Product Change Notification

Product Group: SF/Mon Oct 21, 2024/PCN-SF-00424-2024-REV-0

ECS SERIES INTRODUCTION OF A NEW LUBRICANT

Qualification Test Report New lubricant (ref 80937609) for ECS product range	N°: 2441103
---	--	-----------------------

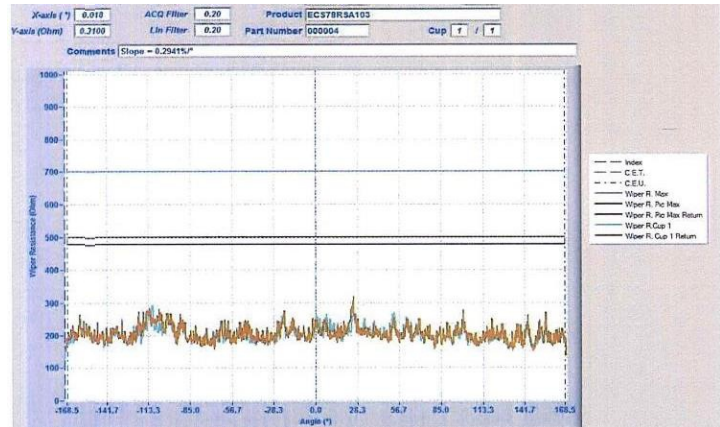
Analysis of results:

The linearity drift is in the acceptance criteria.

After testing, a reduction of dynamic contact resistance in the operating area was observed.

Example of linearity and contact resistance curves after test. The totality of the curves are available on demand.
Examples of low drift of linearity and contact resistance

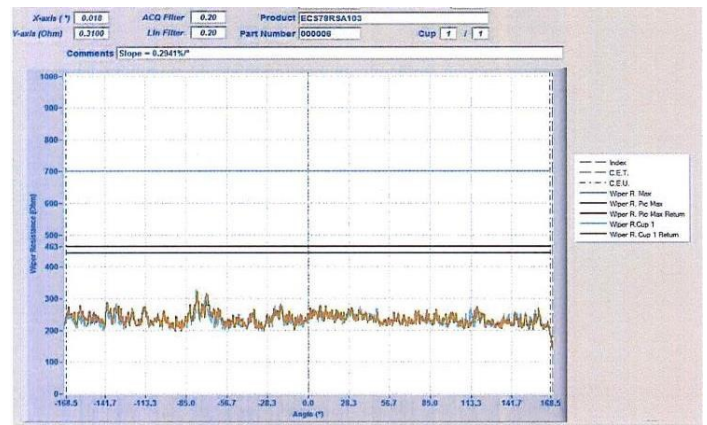
Comment:

We note no drift on linearity after test.

We note a decrease in the contact resistance in the working area (90% of the track)

Example of high drift of linearity and contact resistance

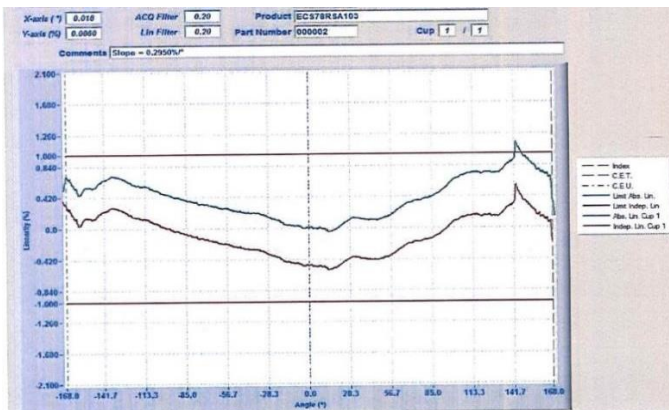
Comment:

We note drift on linearity after test but it steels under the defined criteria.

We note a decrease in the contact resistance in the working area (90% of the track)
